Panoramic Sliding Sunroof Reverses During Closing Without Obstruction – No Anti-Pinch Event Triggered

Topic number	LI77.21-P-075806
Version	7
Function group	77.21 - Panoramic roof
Date	4/20/26
Validity	BR296 with SA code 413 (panoramic roof), produced up to 03/08/2023; BR294 without world manufacturer code LE4, with SA code 413 (panoramic roof), produced up to 03/09/2023; BR294 with world manufacturer code LE4, with SA code 413 (panoramic roof), produced up to 02/01/2023
Reason for change	Retrofitting the vehicles in question to meet Cleanpoint level status.

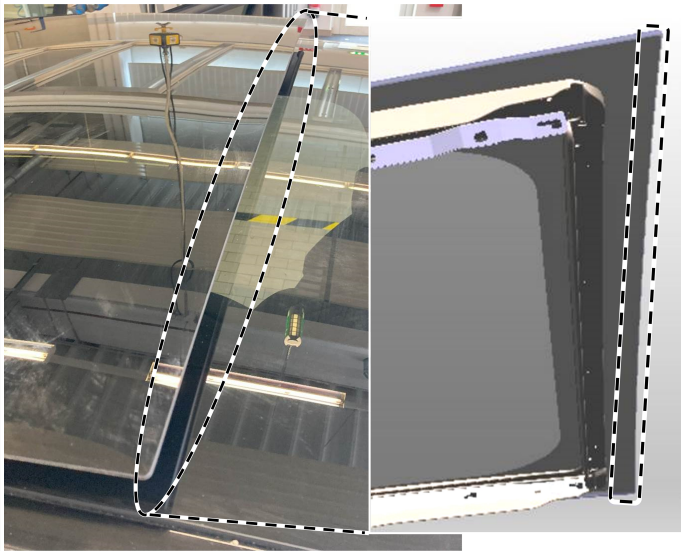
1) Retrofit the EPDM lip onto the rear edge of the panoramic sliding roof panel:

- Clean the underside of the rear edge of the sliding sunroof panel (marking, Figure 1) (e.g., isopropanol).
- Subsequently install the cover rail on the underside of the sliding sunroof panel (Figure 2).

- Distance from the cover rail to the rear edge of the sliding sunroof panel A = 5 mm
 - Distance from the cover rail to the right and left edges of the sliding sunroof panel B = 9 mm

- Apply firm pressure by hand along the entire bonding surface of the COVER RAIL
 - The wider flange at the ends of the cover rail (see Figure 3) must point in the direction of travel

Abbildung 3.jpg

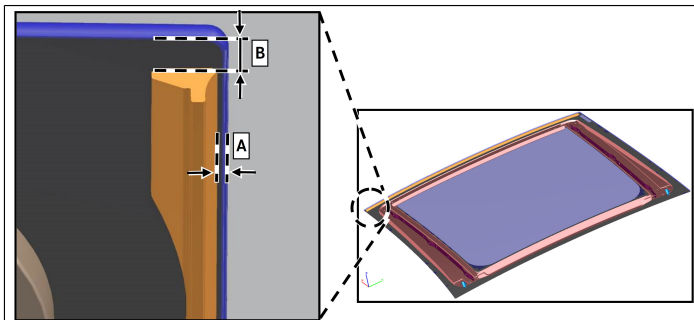
The wider flange at the ends of the cover rail must be oriented in the direction of travel.
